**CITY OF AVON LAKE  
PLANNING COMMISSION  
150 Avon Belden Road  
Avon Lake, Ohio 44012  
(440) 930-4110**

**AGENDA  
Tuesday, June 3, 2025  
7:00 PM  
City Council Chambers**

**Re:** Case No. CPC-24-18, MDC Ventures LLC, Site Plan Approval for the Construction of a New Corporate Office at 32870 Pin Oak Parkway.

Reference: Improvement Plans for Proposed Tomshack Building  
32870 Pin Oak Parkway

**TOMSHACK'S PROPOSED BUILDING SITE PLAN**  
PROPOSED SITE & DIMENSION PLAN  
CITY OF AVON LAKE, LORAIN COUNTY, OHIO

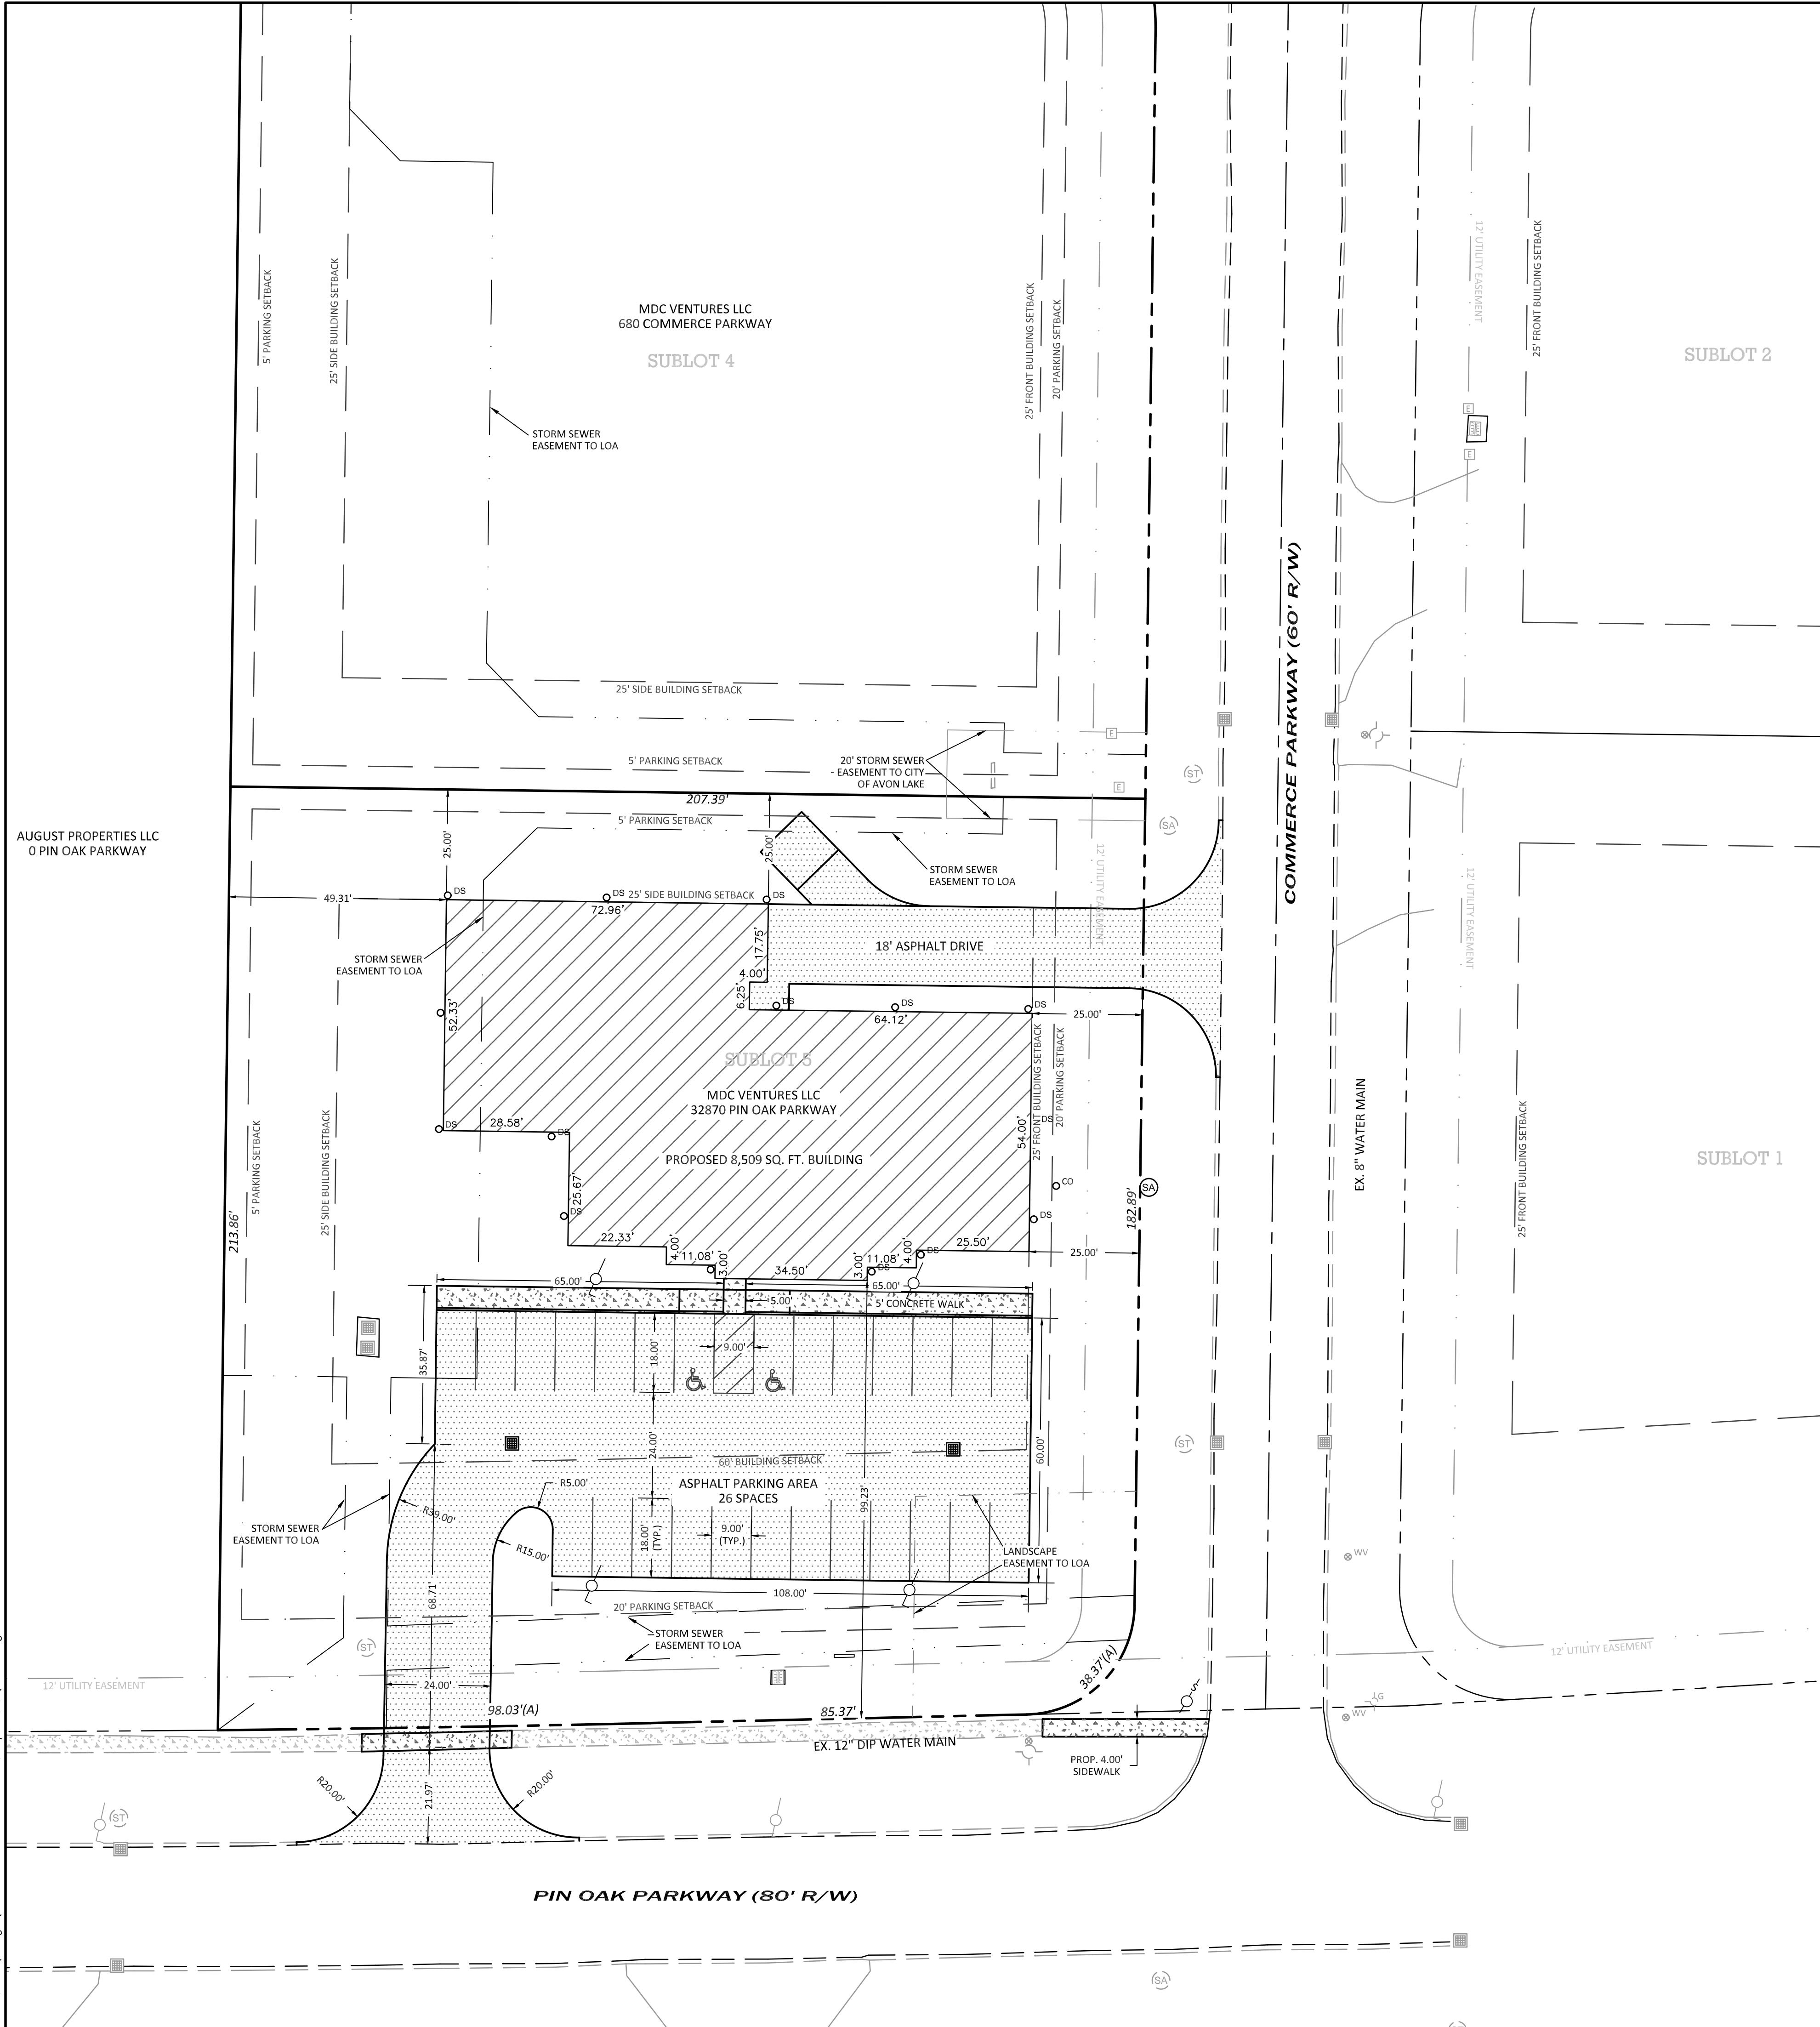
10. Sidewalks will be required to be installed as well as an ADA compliant ramp at the corner of Pin Oak and Commerce Parkway. The sidewalk shall be at least 4' wide and shown on site plan. A detail should also be provided on the detail sheets.

11. My apologies if missed but Commerce Pkwy stop sign shall be depicted on the site plan.

13. Add the zoning district setbacks, variance granted setbacks and max building height (45') to the site data table.

TOMSHACK'S PROPOSED BUILDING SITE PLAN  
PROPOSED UTILITY & GRADING PLAN  
CITY OF AVON LAKE, LORAIN COUNTY, OHIO

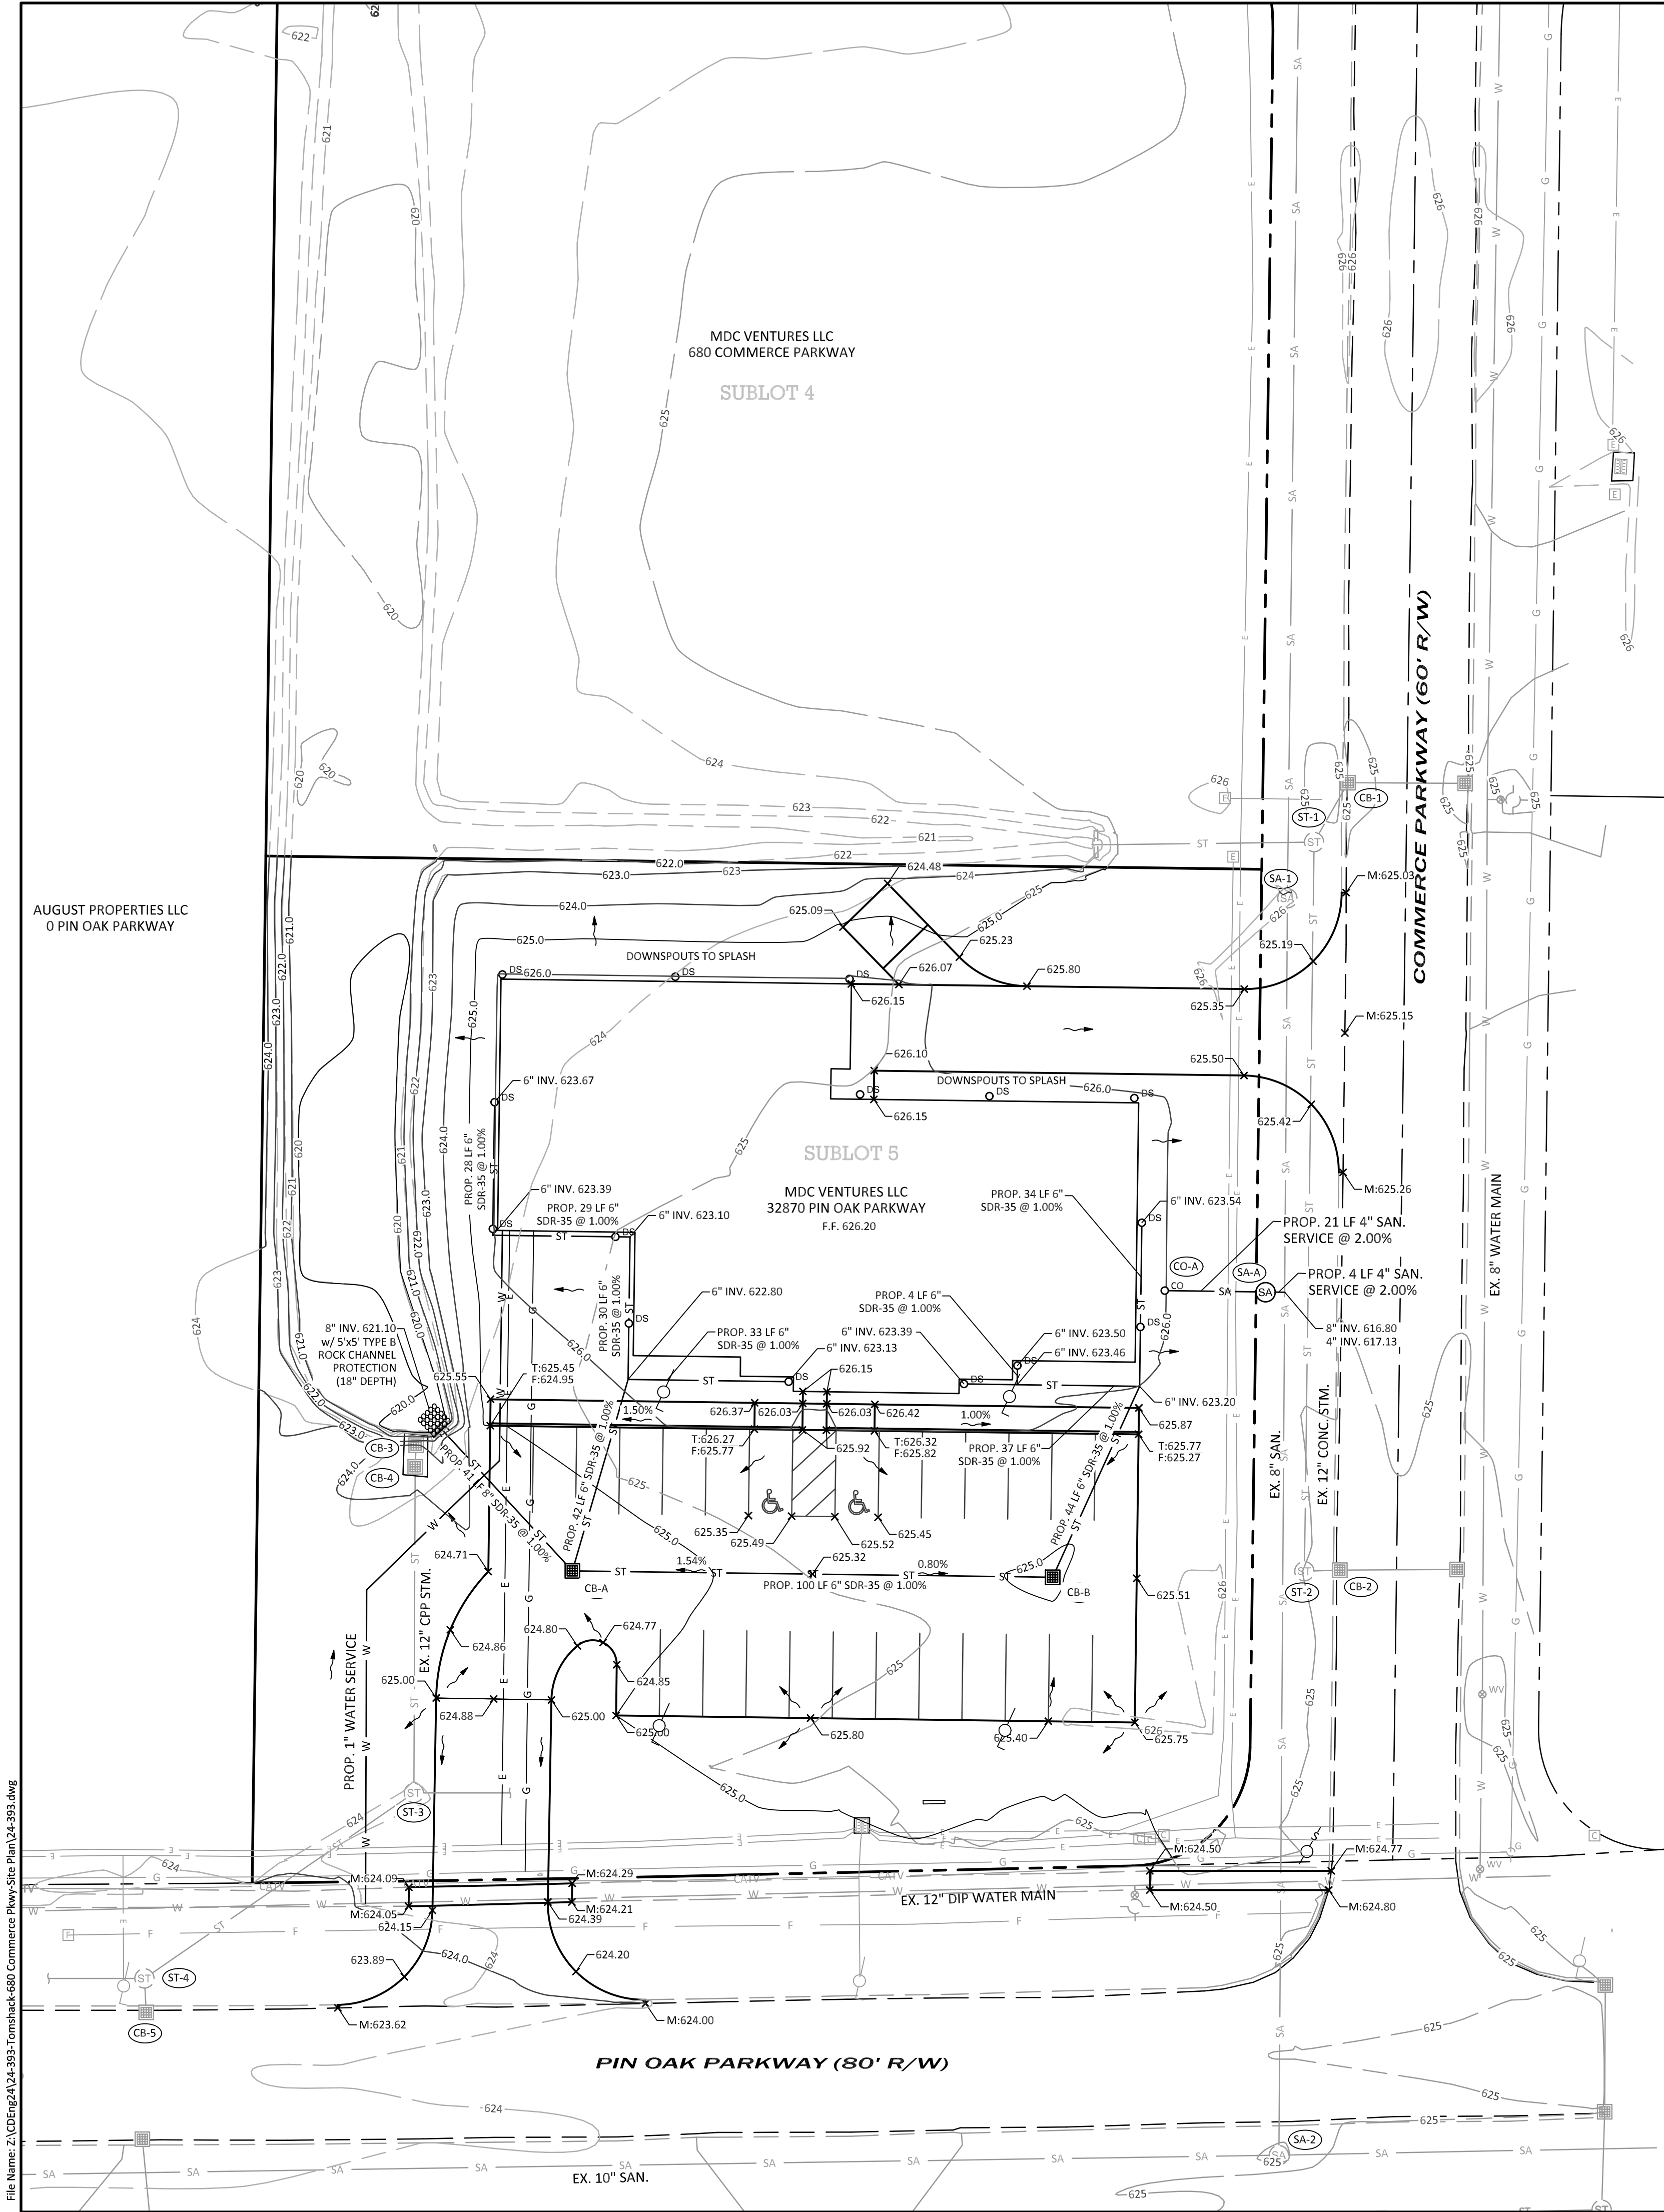
Jarod, based on Kelly's instruction, we are revising the plans prior to the June meeting. If we design 2 cleanouts, will they replace the "sample manhole" that you have marked up on the plans? If not, is there a specific detail that you could provide that must be added to the plans for what is requested for the manhole. Thank you in advance for your clarification.

No, cleanouts will not replace the sampling manhole. All commercial properties are required to have a dedicated sampling manhole. It is a standard 4' diameter (ID) precast concrete sanitary manhole. I have uploaded an plan sheet excerpt with our standard details for such.

POLE MTD. TYPE "A" FIXTURE DETAIL

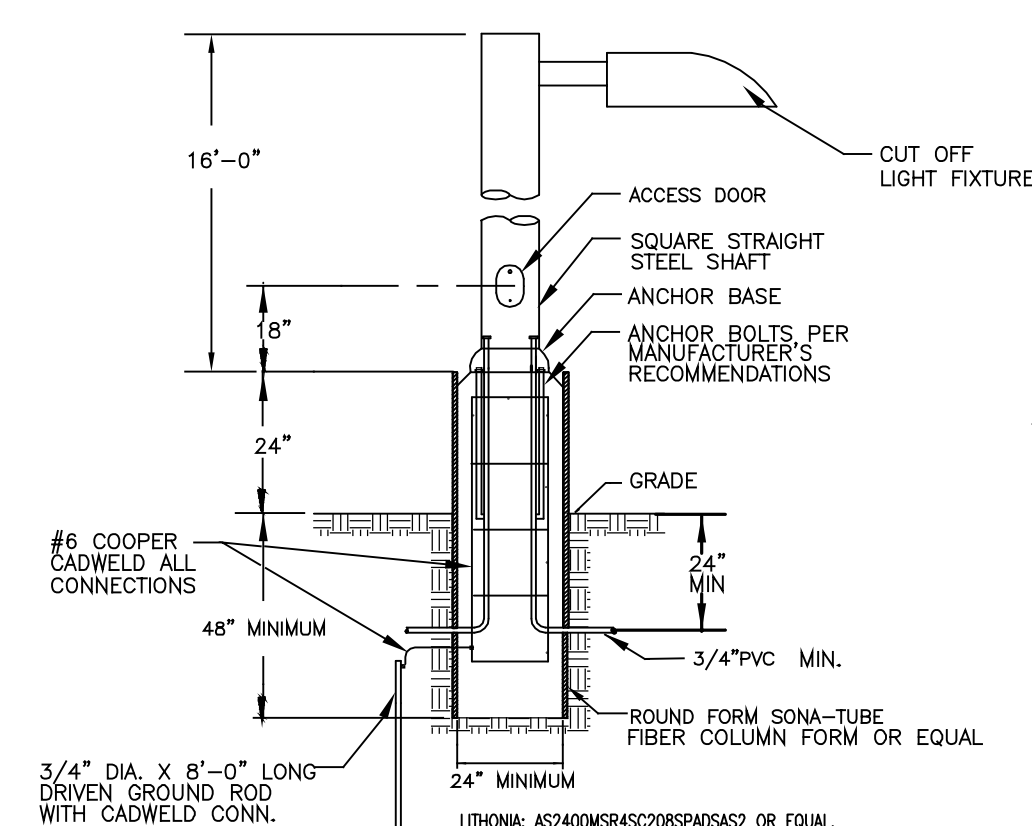
6. How tall are the proposed light poles in the parking lot? Please provide details. Not permitted to exceed a height of 30'.

6. How tall are the proposed light poles in the parking lot? Please provide details. Not permitted to exceed a height of 30'.
